**SECTION 00 90 02
BIDDING AND CONTRACT REQUIREMENTS
ADDENDUM NUMBER 2**

Issued: November 1, 2024

Re: ADDENDUM NUMBER (2) TO THE BIDDING DOCUMENTS FOR

**McHenry County College
2024 Renovations – Bid Package 2**
Architect's Project Number: 24-013

1 LIGHTING PLAN - LIBRARY
1/8" = 1'-0"

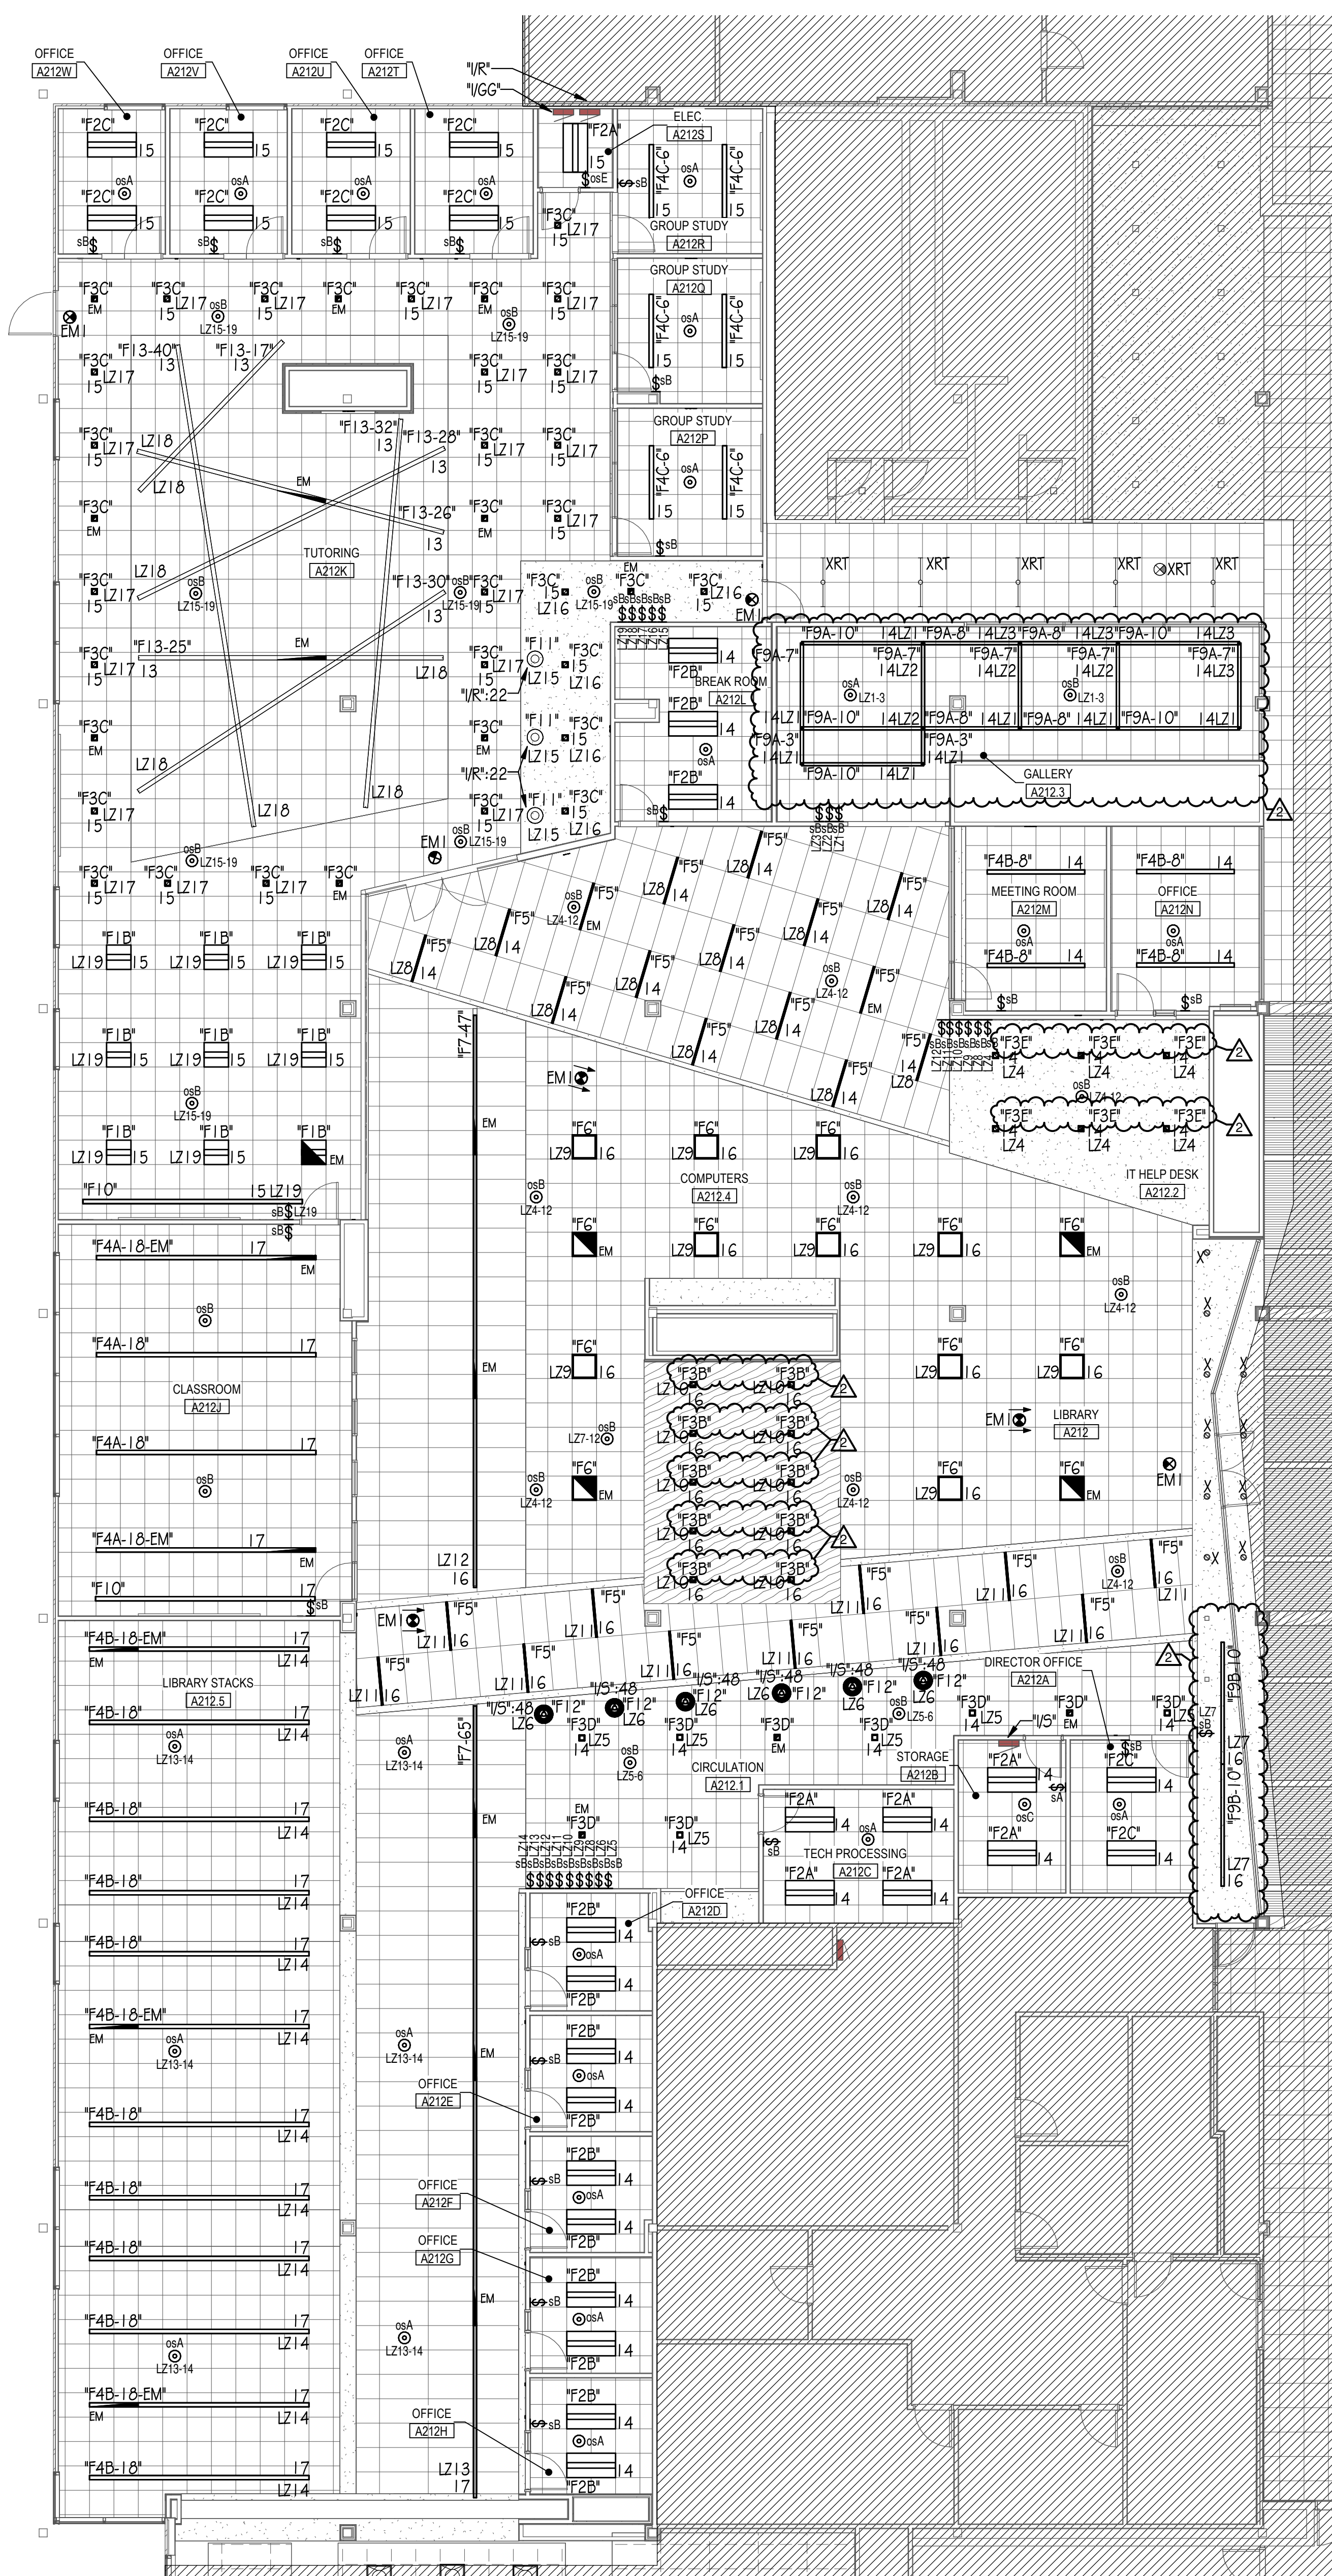
- C. **DELETE** ceiling mounted fire alarm device at IT Help Desk A212.2.
 - D. **DELETE** (1) floor box at Library A212.
- 4. E2.20
 - A. **REVISE** lighting layout outside Directory Office A212A.

- B. **REVISE** luminaire type in wood ceiling panel at Library A212.
 - C. **REVISE** luminaire type at IT Help Desk A212.2.
 - D. **REVISE** luminaire type at Gallery A212.3.
